Well Name: HONDO FEDERAL	Well Location: T18S / R27E / SEC 4 / SWNE /	County or Parish/State: EDDY / NM
Well Number: 6	Type of Well: OIL WELL	Allottee or Tribe Name:
Lease Number: NMNM29278	Unit or CA Name:	Unit or CA Number:
US Well Number: 300152905300S1	Well Status: Producing Oil Well	Operator: REDWOOD OPERATING LLC

**Notice of Intent**

Type of Action: Plug and Abandonment

## Plug Abandonment NOI Proposed

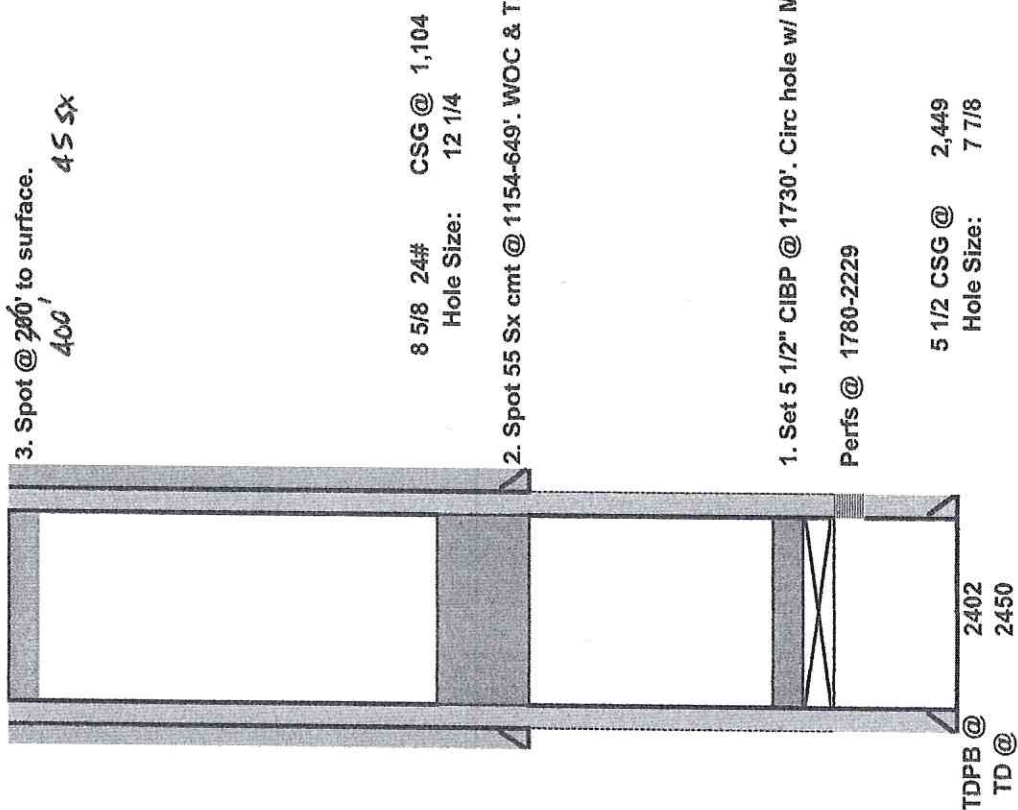
*High Cave*

1. Set 5 1/2" CIBP @ 1730'. Circ hole w/ MLF. Pressure test csg. Spot 25 sx cmt @ 1730-1530'.
2. Spot 55 Sx cmt @ 1154-649'. WOC & Tag (8 5/8" Shoe & Queen)
3. Spot @ 200' to surface. *400' to surface 45 sx*
4. Cut off well head, verify cmt @ surface, weld on Dry Hole Marker.
